December 10, 2019

**Addendum No. 01
TO THE CONTRACT DOCUMENTS FOR:**

MANSFIELD FIRE STATION NO. 4

KAI Project No. 2016.166

DOOR TYPES

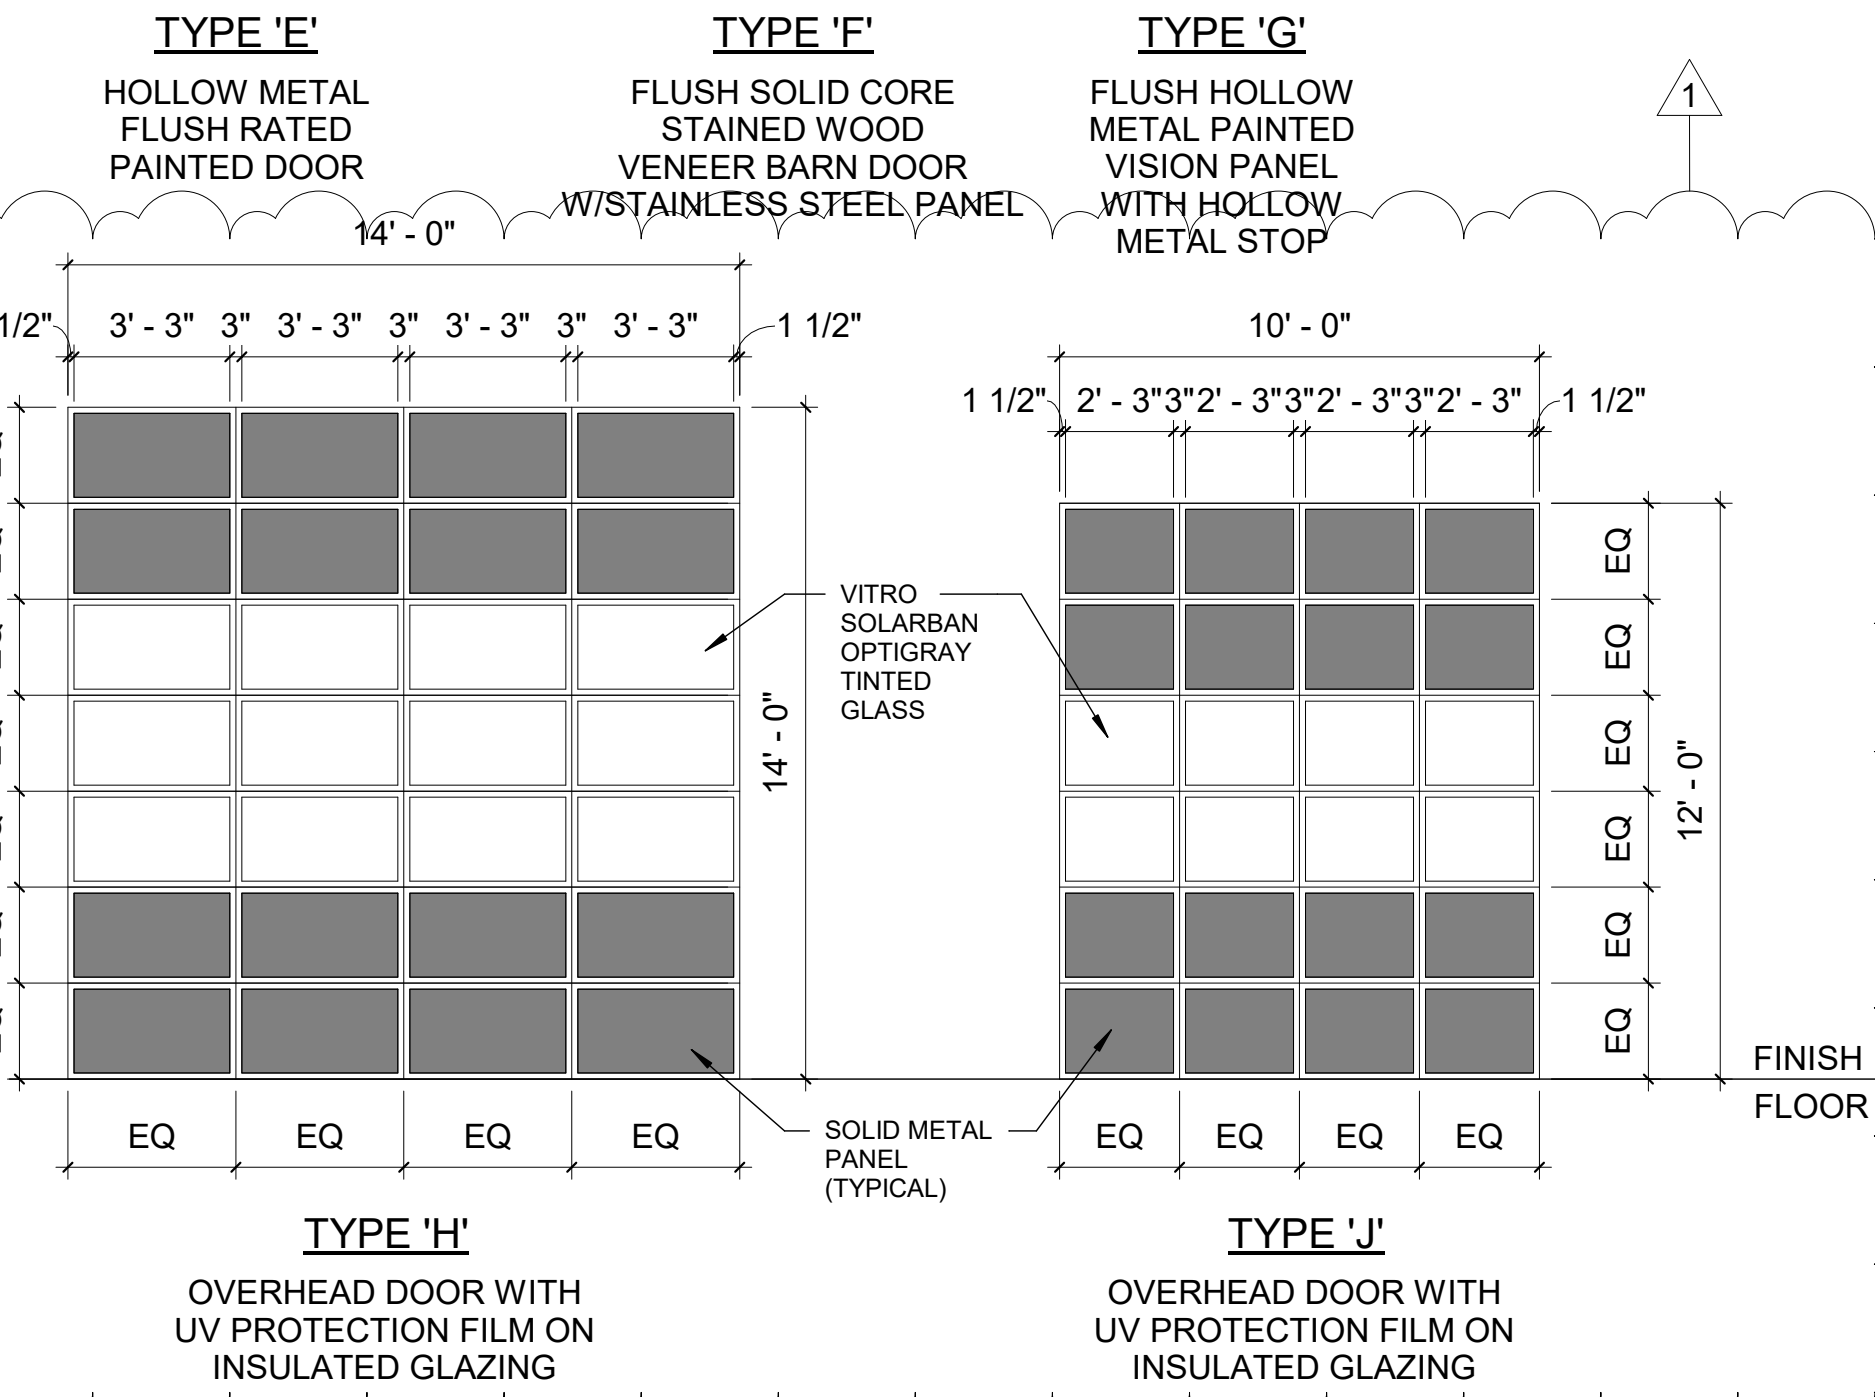
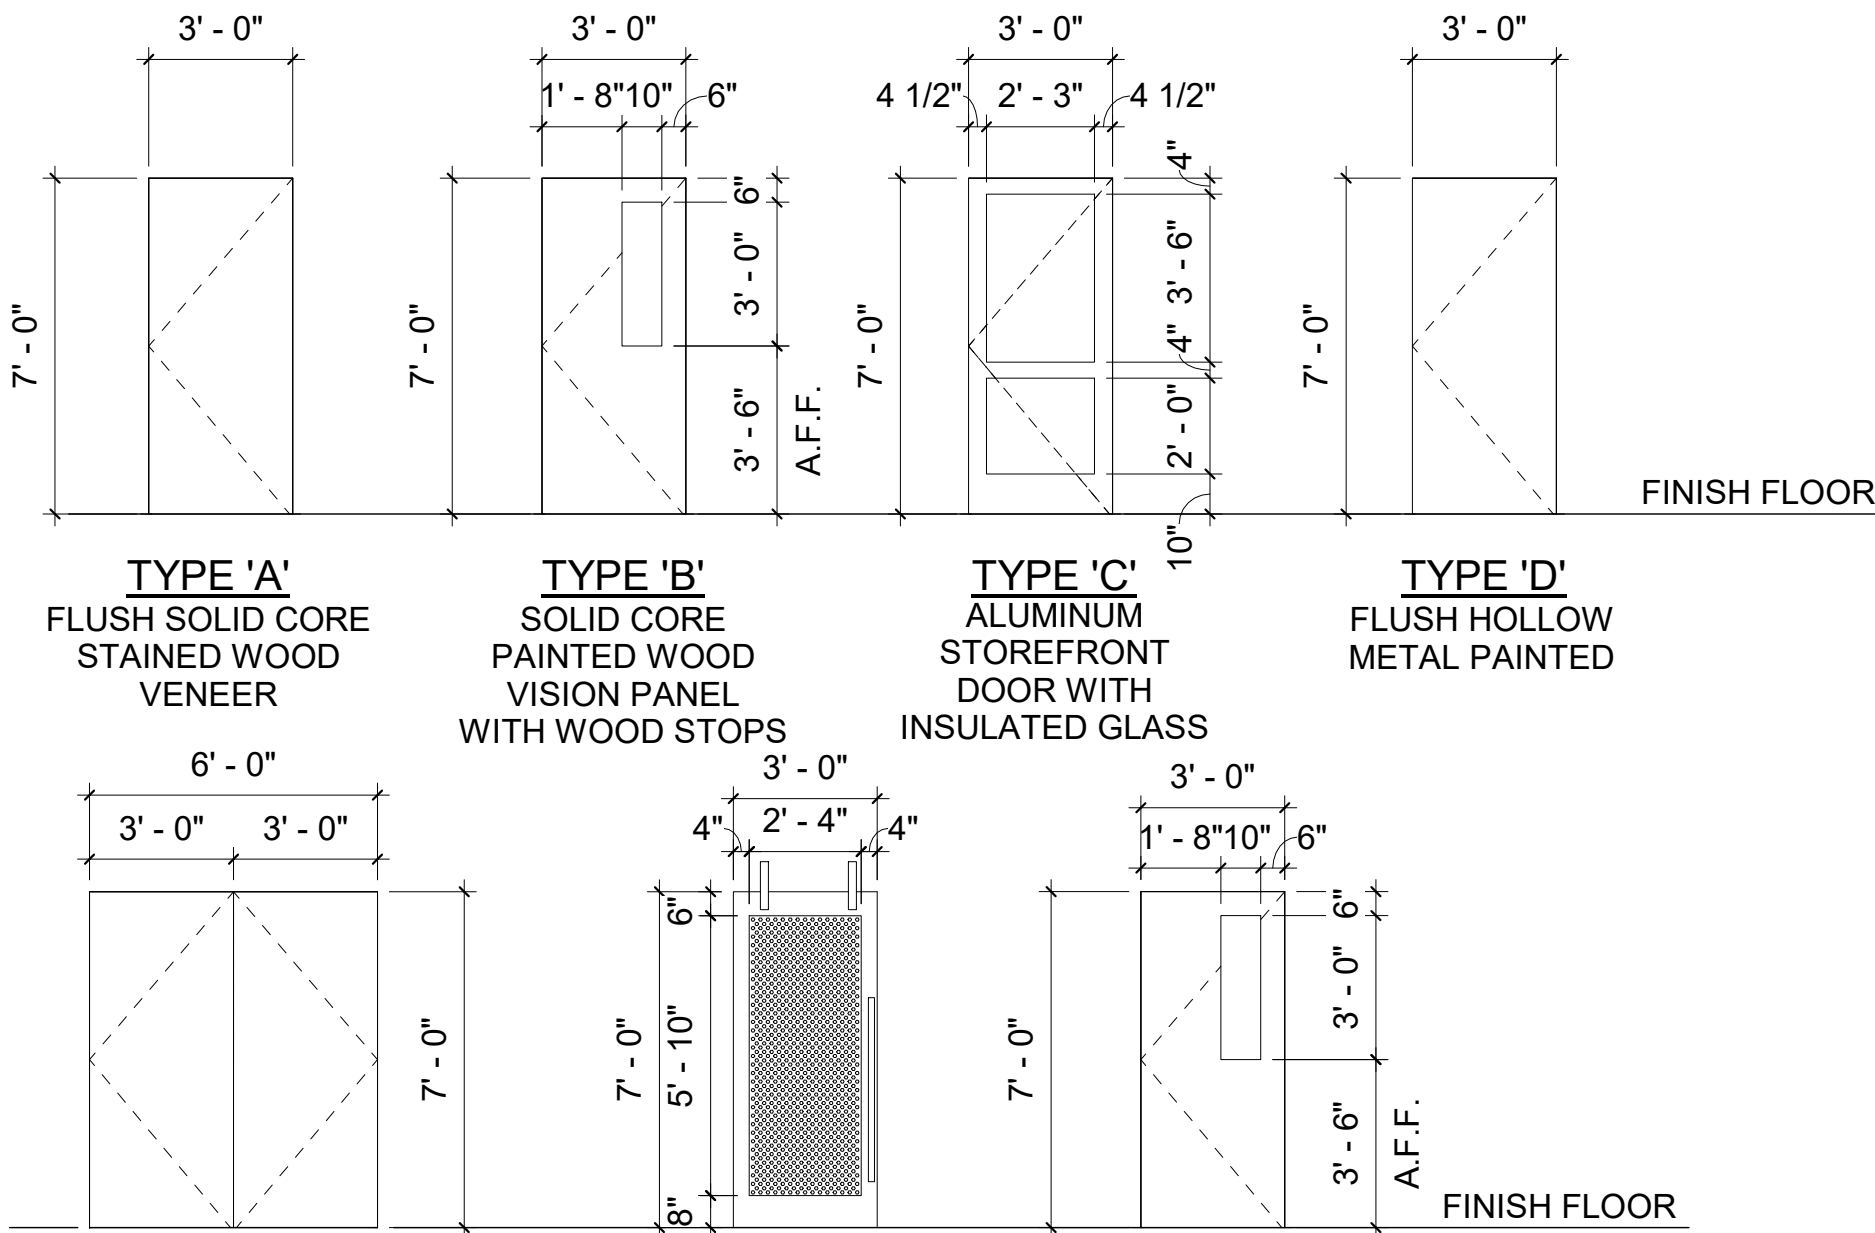
15. Sheet A6.01
 - a. DOOR TYPES - Revised type doors H and J to show solid metal panels. Glass to be tinted to match Vitro Solarban Optigray.
 - b. DOOR SCHEDULE – Clarified door types and materials.

01 GENSET FOUNDATION PLAN 1/4" = 1'-0"

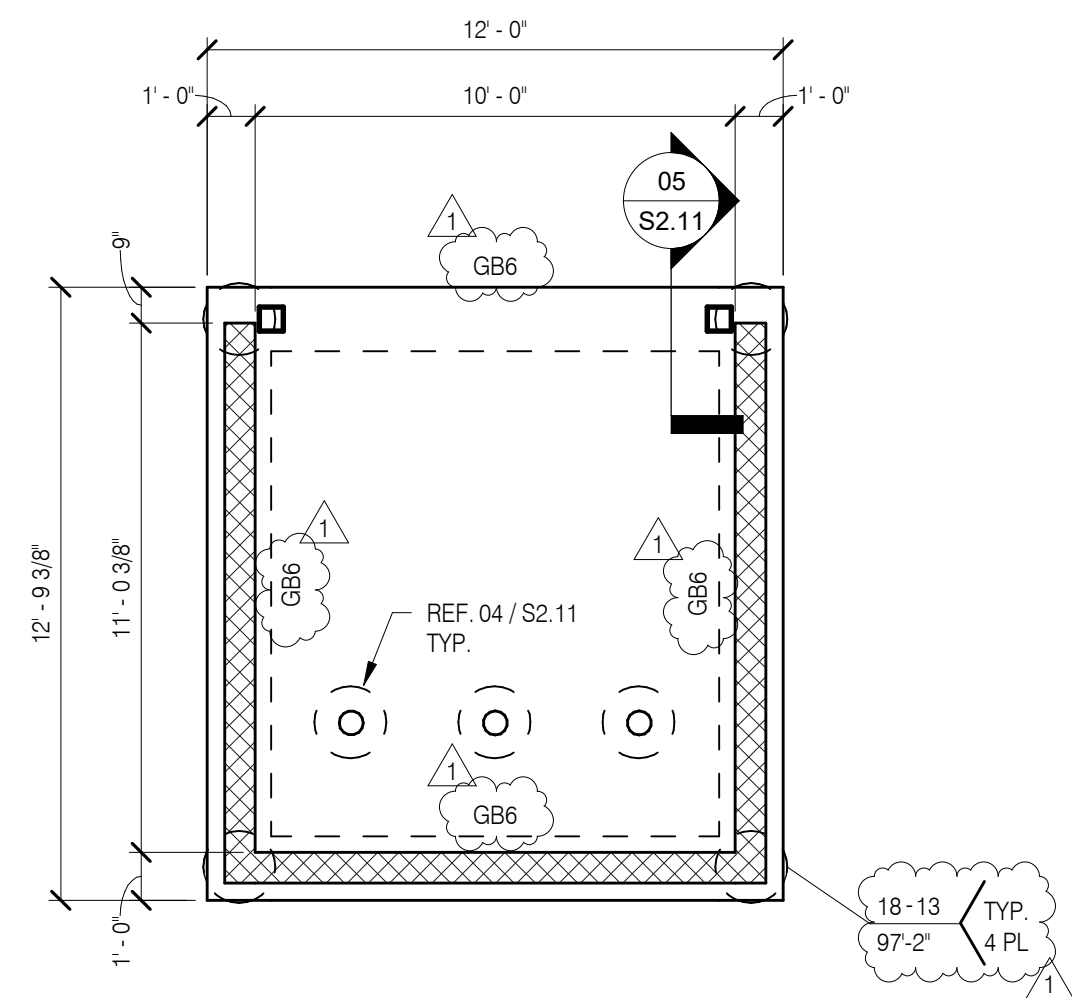
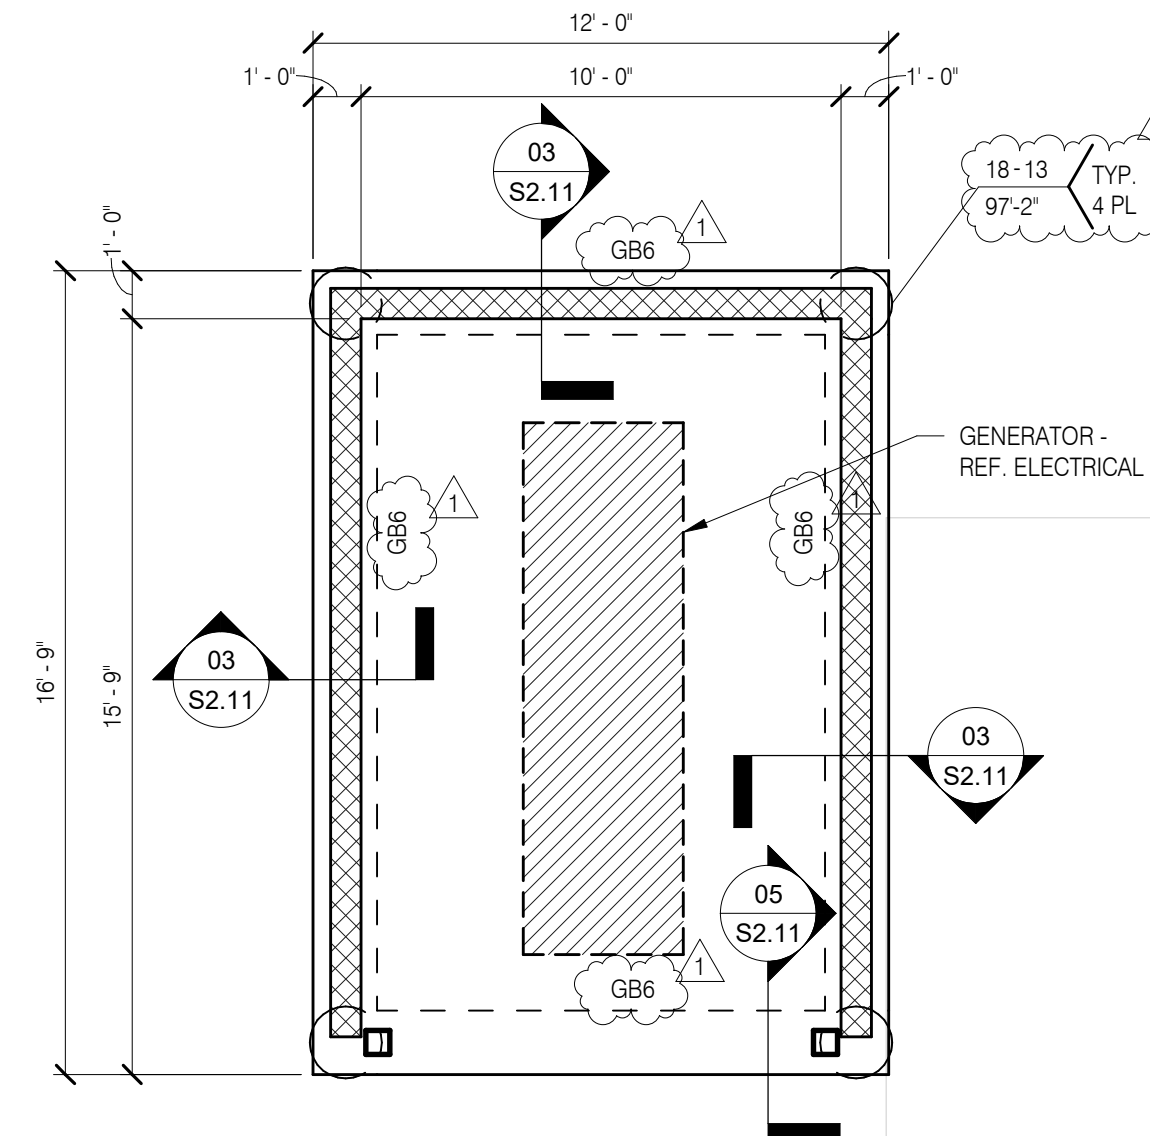
16. Sheet A6.02 – Window Type F to have G1 type glass.
17. Sheet S2.10 – GRADE BEAM SCHEDULE – Clarified grade beam stirrup reinforcing.
18. Sheet S2.11 – Plans 1 and 2 - Clarified pier sizes at dumpster and generator enclosure.

KOMATSU ARCHITECTURE		12/10/19	
ISSUE FOR CONSTRUCTION		Date	
Revision 1		No.	
MANSFIELD FIRE STATION NO. 5		REVISIONS	
4444 NATIONAL PARKWAY MANSFIELD, TEXAS 76063		Description	
ROOF FRAMING PLAN		12/10/19	
SHEET SIZE: 22 x 34		DATE: 11/07/2019	
JOB NO: 2016.166		SHEET: S2.30

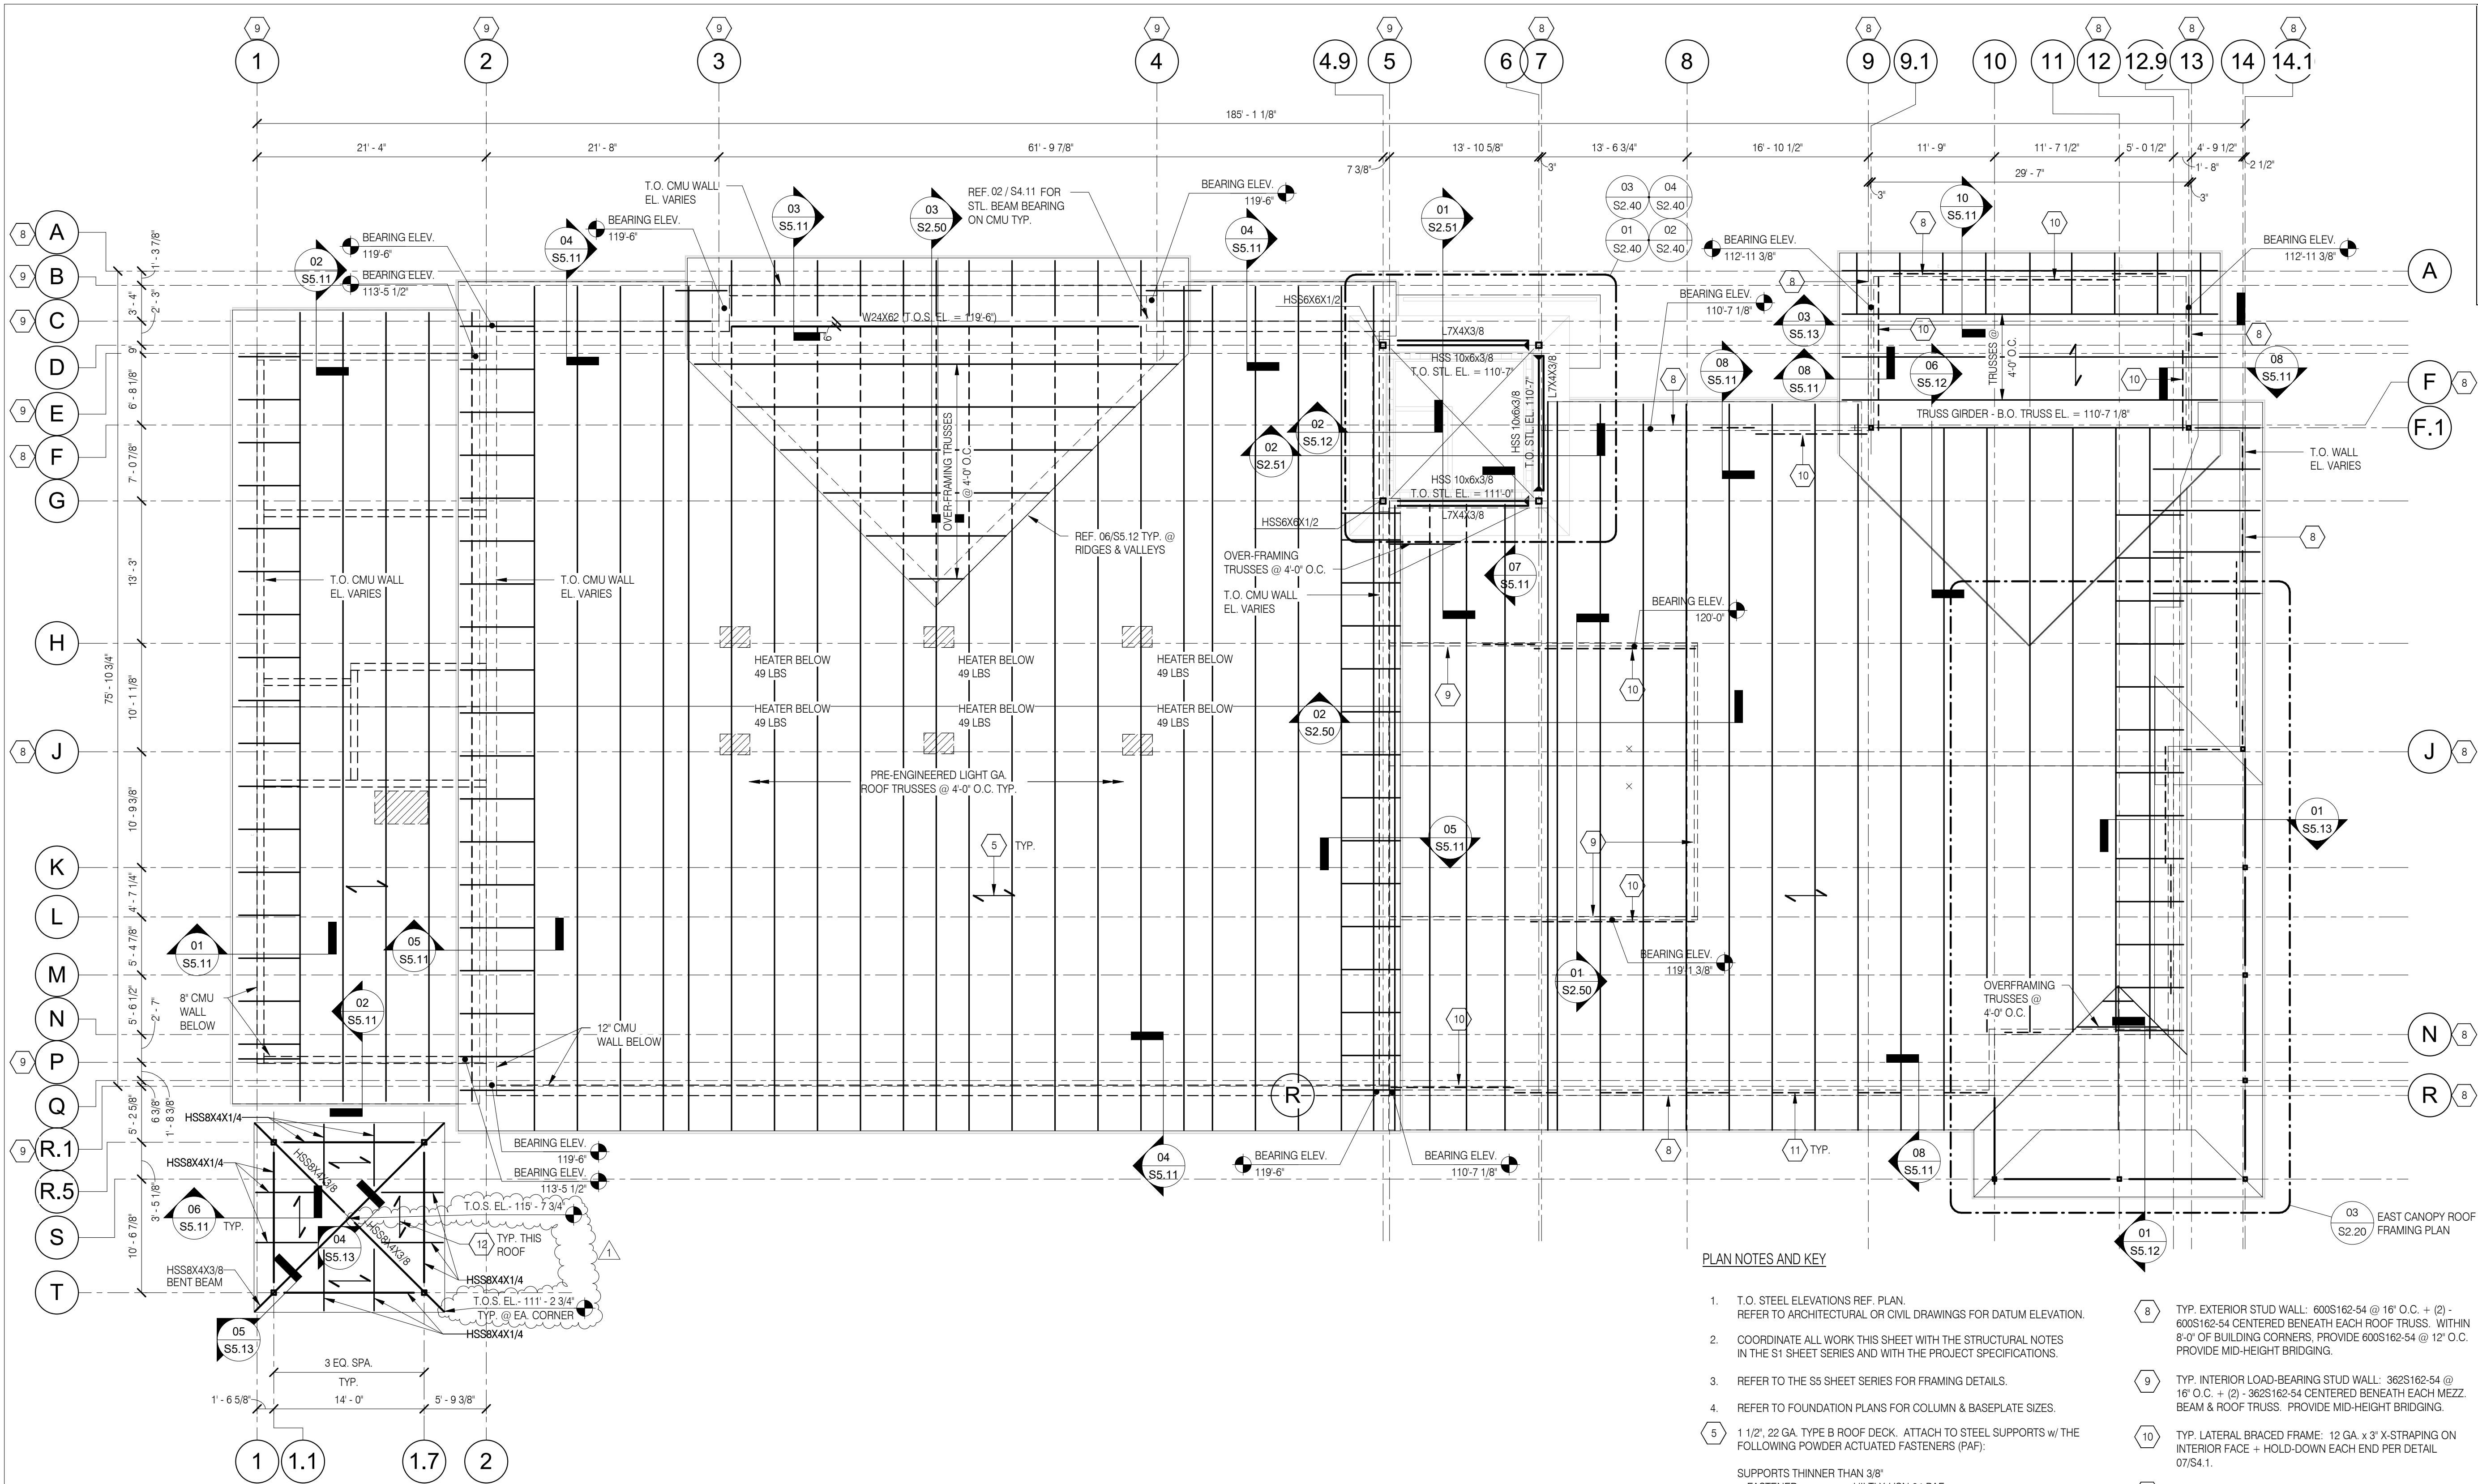
19. Sheet S2.30 – Revised top of steel elevations for workout structure.
20. Sheet S3.12 – Detail 1 – Replaced Longitudinal bar schedule with Typical Stirrup detail.
